Technical Service Bulletin: tsb100289

New Front Gear Housing

This Technical Service Bulletin introduces new front gear housings for QSK45/60 series engines and QSK78 series engines.

Figure 1, New QSK45/60 Front Gear Housing

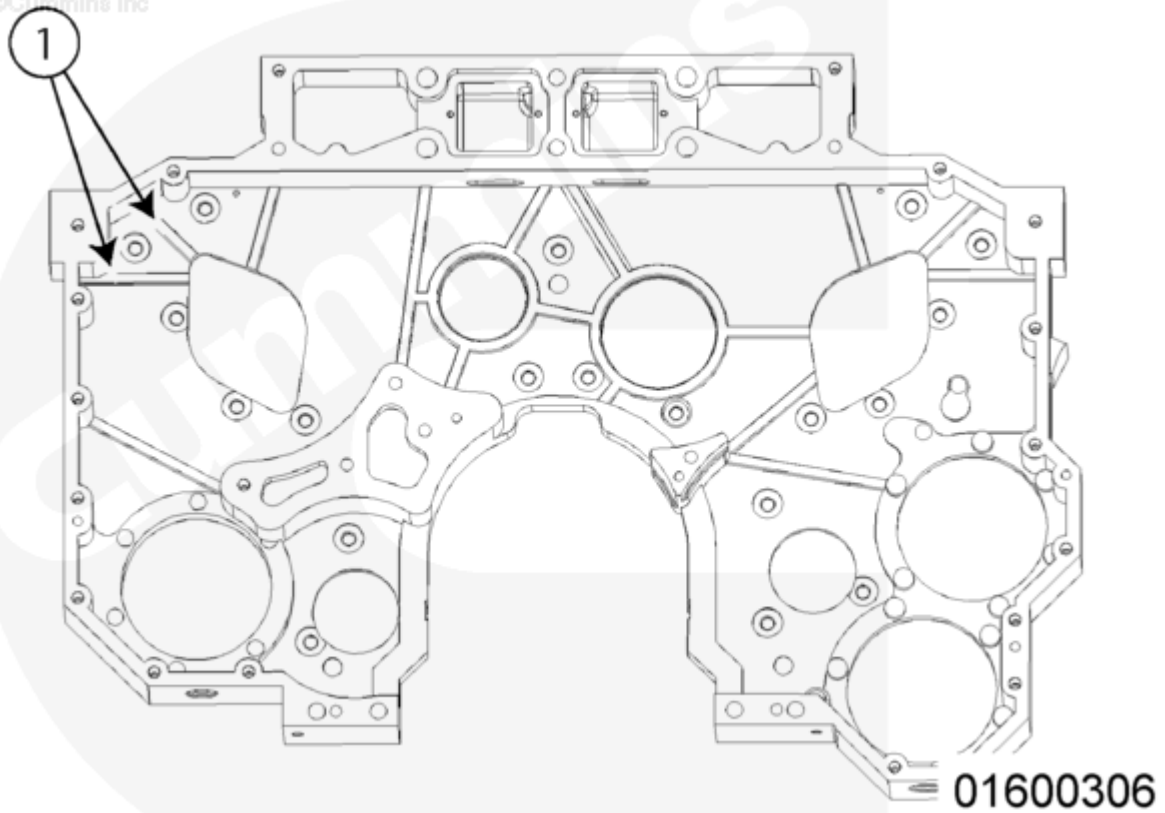
The new design of the QSK45/60 engine front gear housing (Figure 1) incorporates increased bolt hole counterbore fillet radius and two additional strengthening ribs (1).

Engine Serial Number first was 33155621, built 13th January 2004.

The old QSK45/60 gear housing Part Number, 4016512 has been made obsolete and supersedes to the new gear housing Part Number, 3635814.

Figure 2, New QSK78 Front Gear Housing

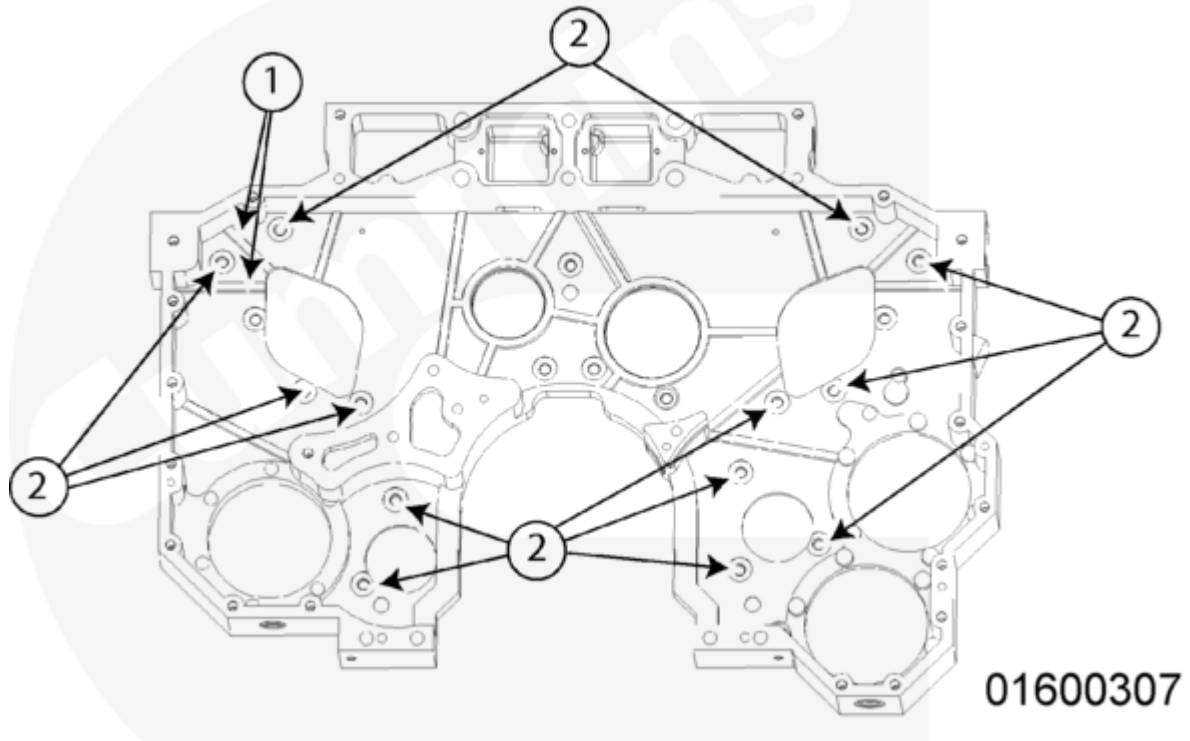
The new design of the QSK78 engine front gear housing (Figure 2) incorporates increased bolt hole counterbore fillet radius, two additional strengthening ribs (1) and increased thickness on thirteen bolt holes (2) from 5.0 mm (0.197 in.) to 8.0 mm (0.315 in.).

Engine Serial Number first was 66300472 built 14th June 2004.

The old QSK78 gear housing Part Number, 4007357 has been made obsolete and supersedes to the new gear housing Part Number, 3636085.
